**B.7.3 Traffic Information Response & Road Impact Assessment  
(Incorporating Traffic Impact Assessment, Pavement Impact  
Assessment & Road Safety Assessment)**

**SCENIC RIM AGRICULTURAL INDUSTRIAL PRECINCT  
RESPONSE TO COORDINATOR GENERAL'S INFORMATION REQUEST**

This letter has been prepared to respond to the Coordinator General's Request for Information (RFI) issued for the project.

With respect to traffic impacts, the items were raised by Scenic Rim Regional Council (SRRC), the Department of Transport and Main Roads (TMR) and Green Grow Pty Ltd. Table 1-1 summarises the traffic related items raised in the RFI.

Figure 1-1 PIA Process

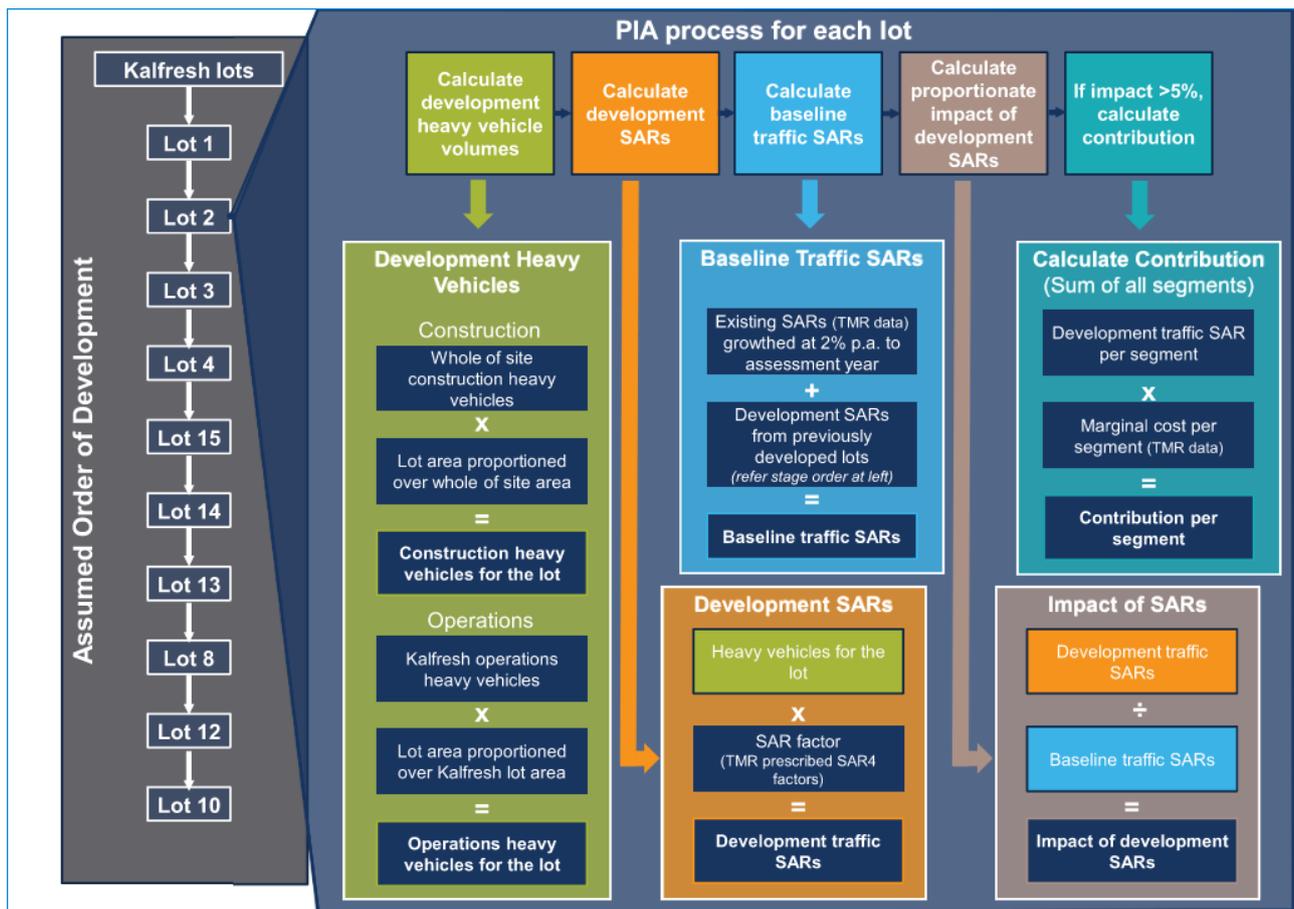
The department has reviewed the PIA submitted and has been unable to replicate the applicant's results based on the information provided. As such the department is unable to confirm that the methodology/contribution proposed by the applicant is accepted.

The applicant needs to provide the department with a copy of the Appendix C calculations so that the department can undertake a more detailed assessment of the pavement impact methodology and the proposed contribution.

Cardno engaged in discussions with the Department of Transport and Main Roads (TMR) regarding this matter and provided copies of the PIA methodology and calculations. The calculations were compiled and issued to TMR on 3<sup>rd</sup> July 2020 for review.

Following this, additional information explaining the methodology process was provided to TMR on 30<sup>th</sup> July 2020, as shown on Figure 1-1. This explained that the PIA assessed each allotment as a new stage, which is reflective of each allotment being completed separately, as is likely to occur in reality. The alternative approach, to assess the entire SRAIP project as one, would severely overstate the pavement impacts as the site would develop over a long period, not at one time.

Figure 8-1 Industrial Street Cross Section

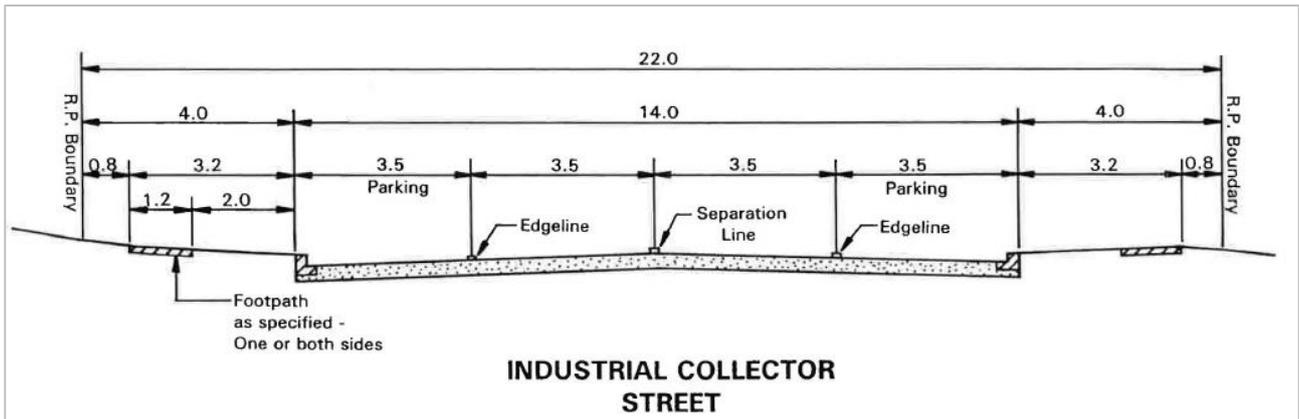
*Confirmation required that pavement widths are sufficient to carry services. Review TIA assessment to confirm.*

A review of the environmental capacity of the proposed internal road has been included in the TIA, at section 8.1.1. The daily traffic demands from the SRAIP and the approved Frazerview quarry are confirmed to be within the daily limits, and therefore the proposed road cross section is considered to be appropriate.

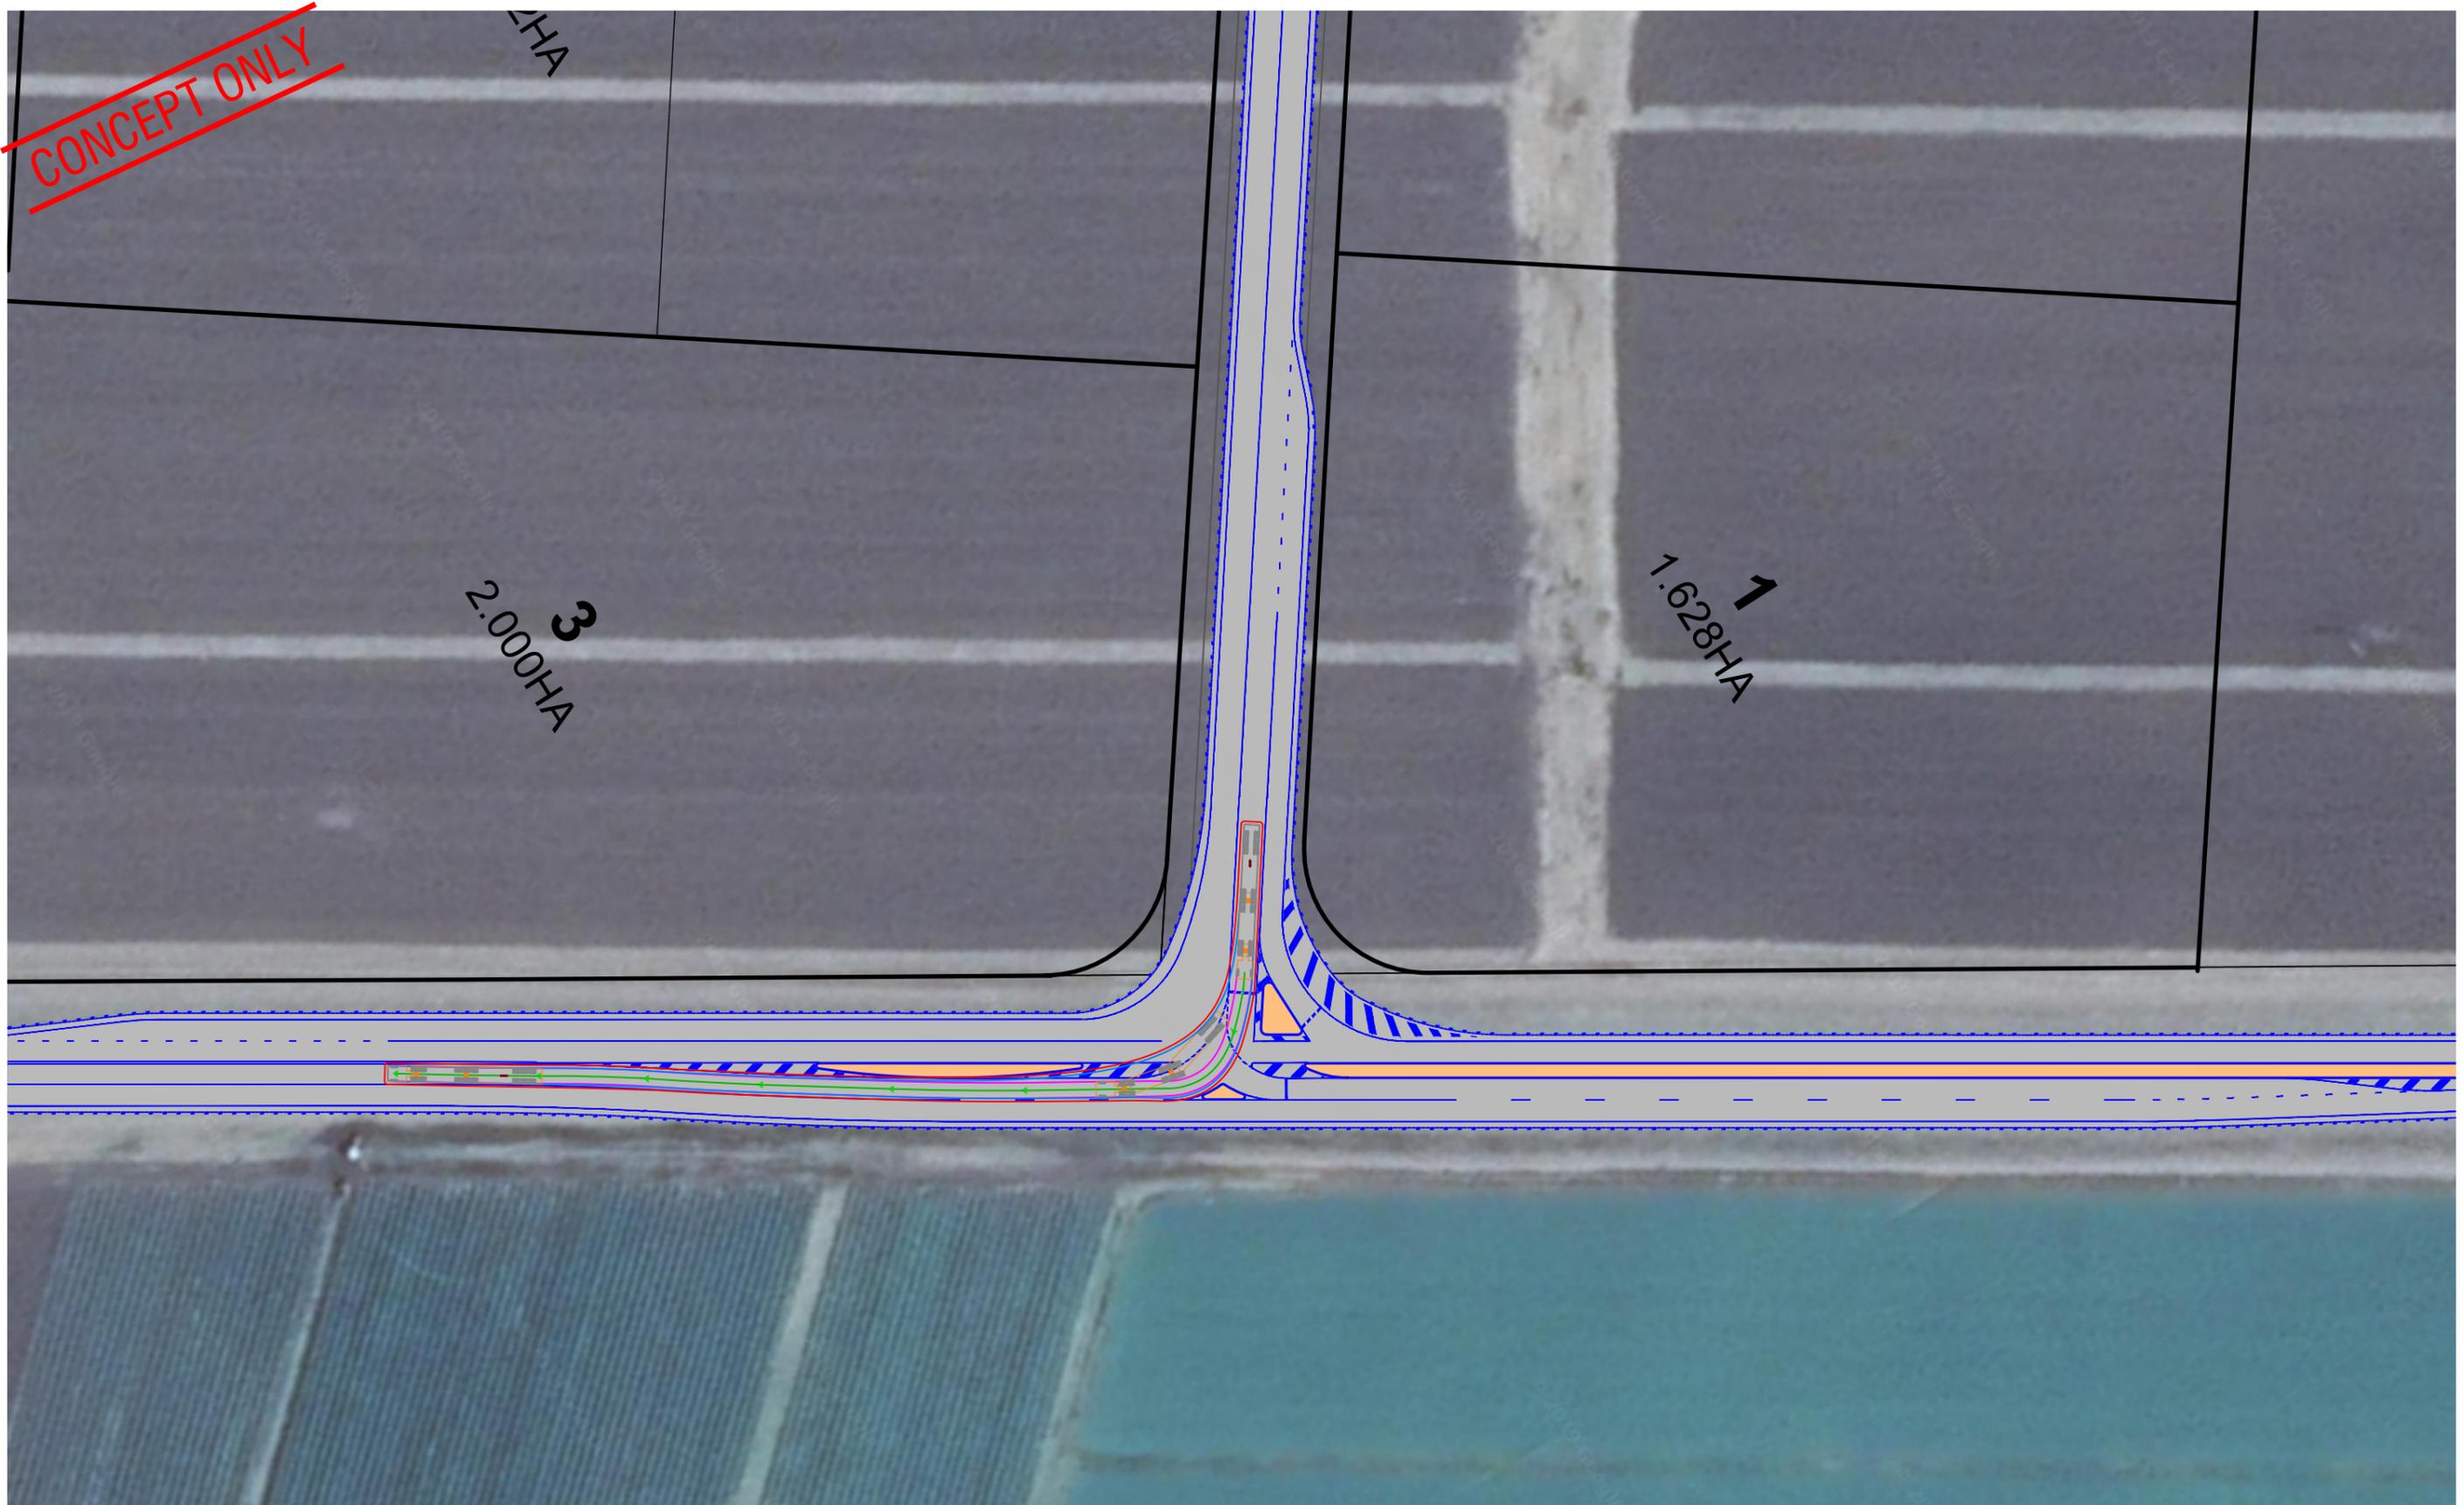
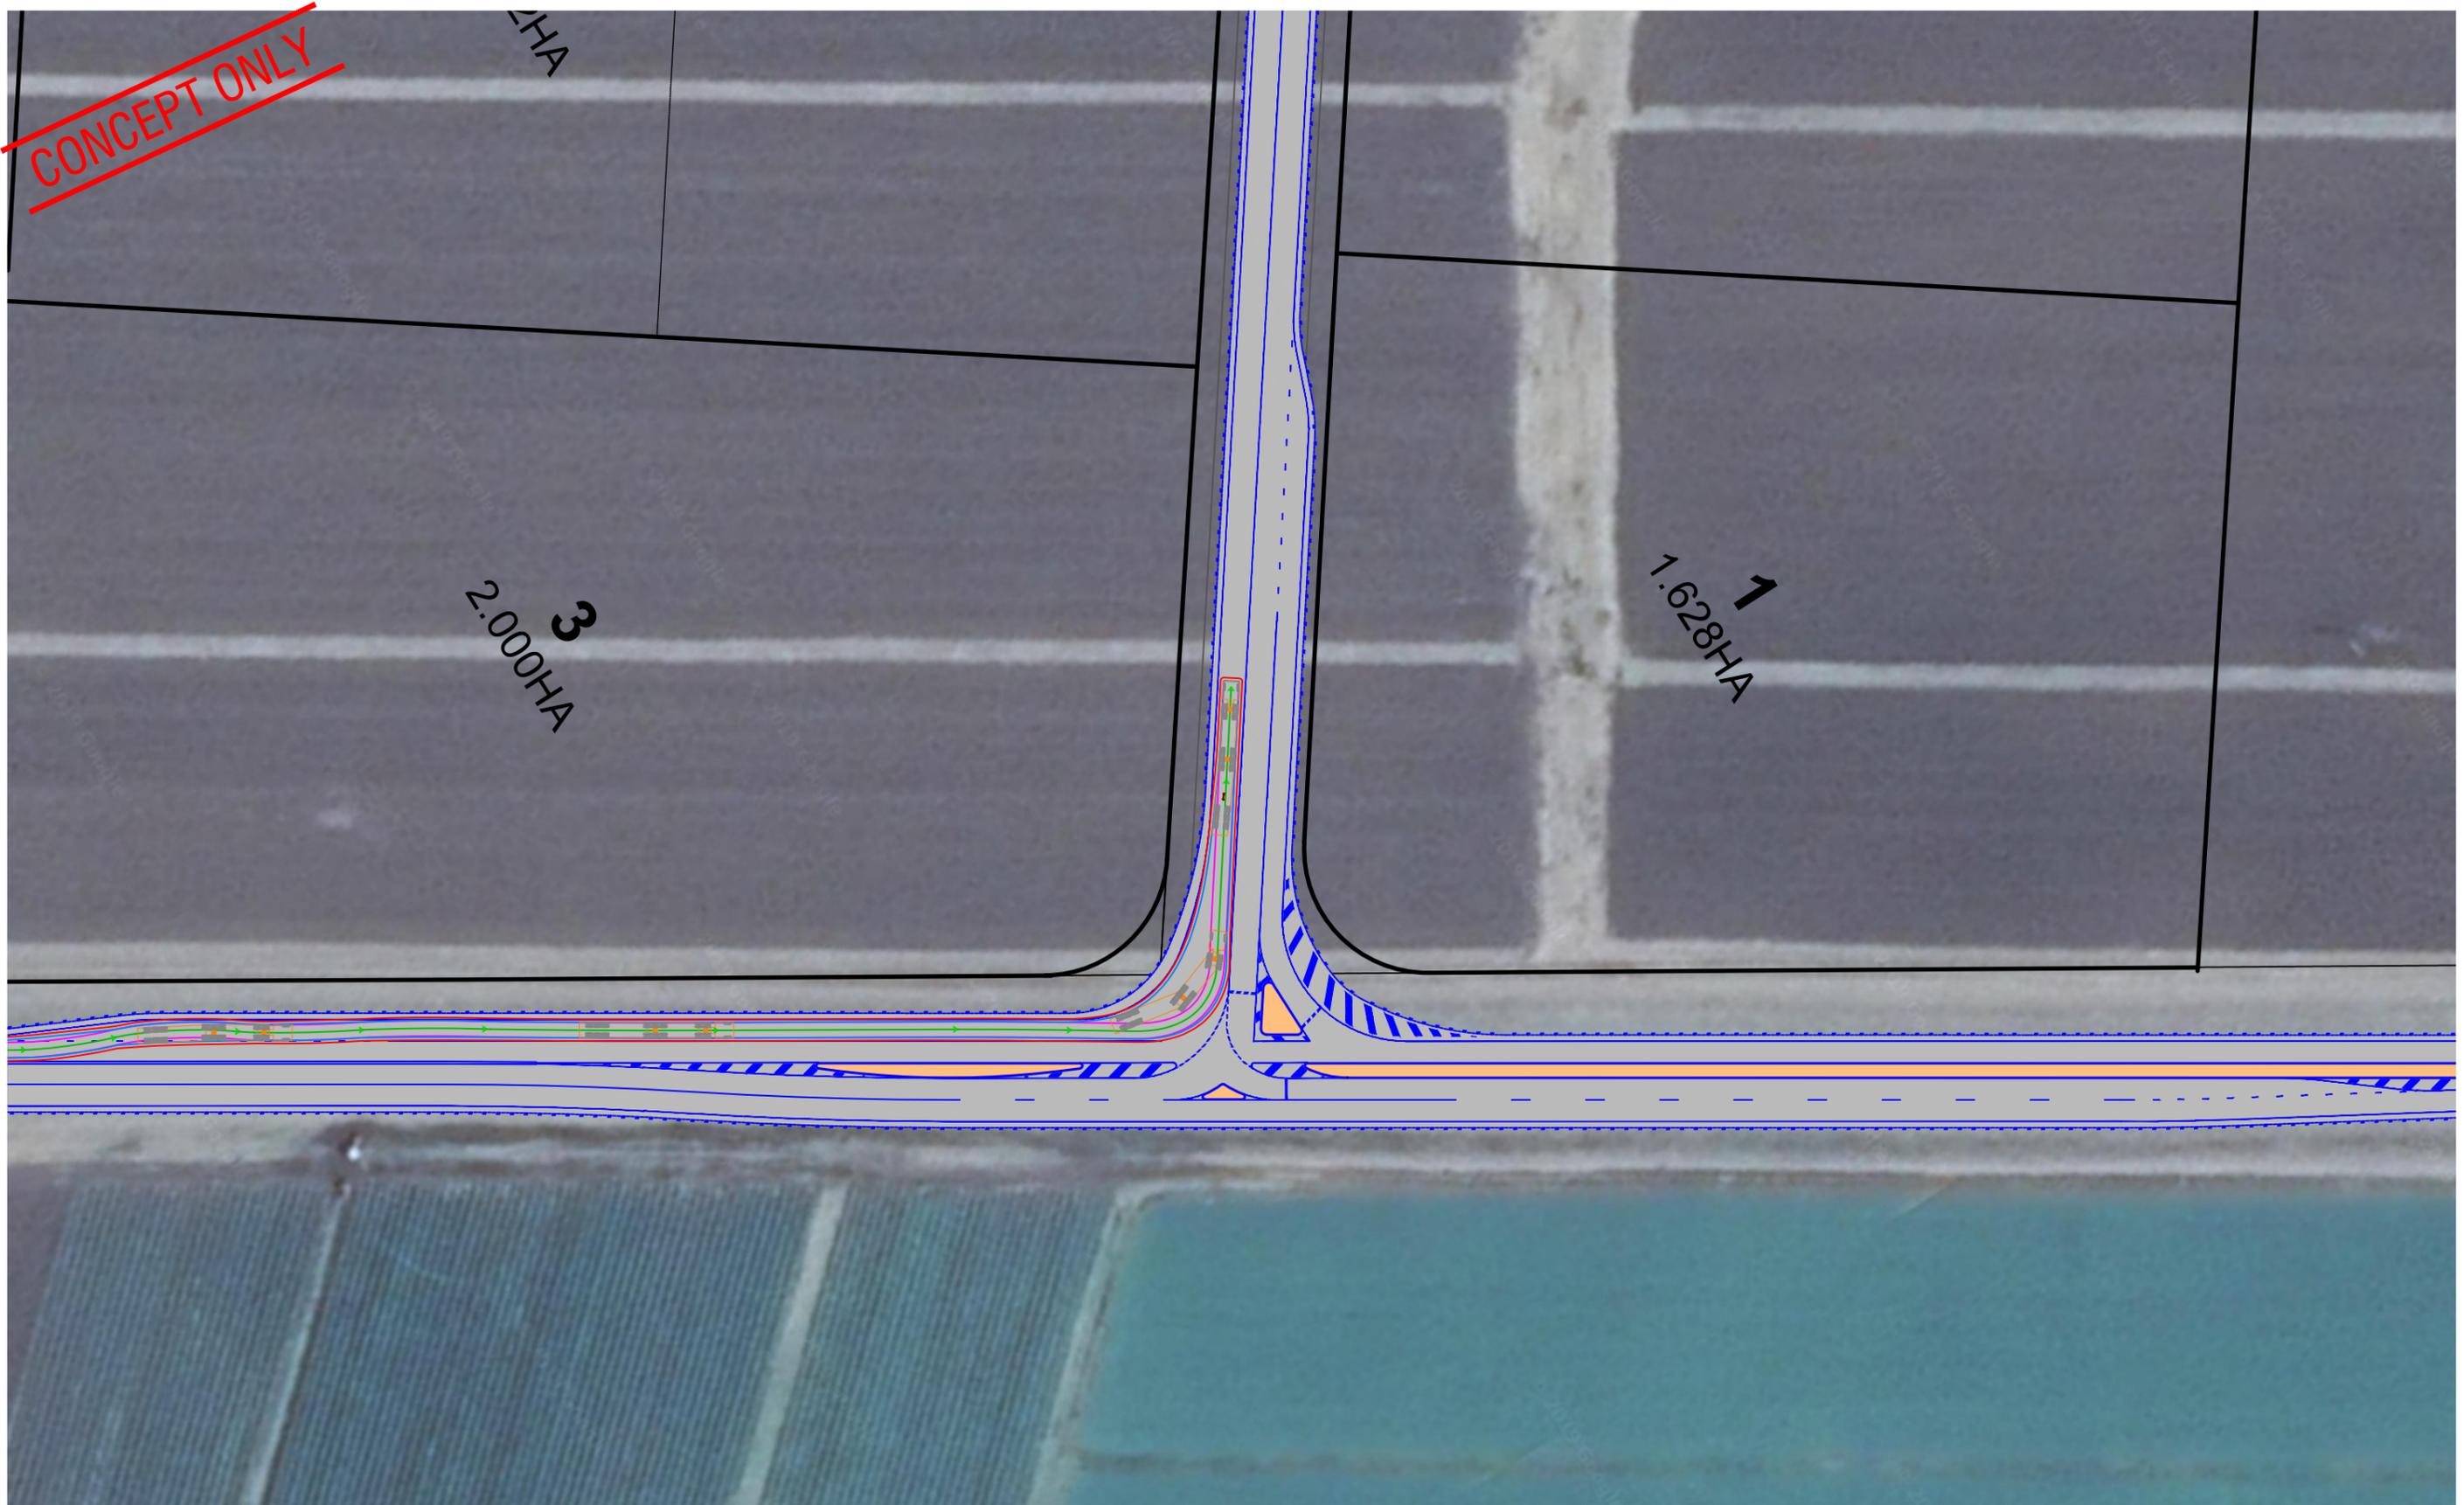
*TIA doesn't address turning movements at new intersection for largest anticipated vehicle based on 22m pavement (parking lanes). Review TIA assessment to confirm.*

The design of the new access intersection on the Cunningham Highway has been based on the swept path movement of the design service vehicle, being a B-double. The swept path drawings 510357 – SK07-SK10 enclosed at **Appendix 2** demonstrate the suitability of the intersection design.
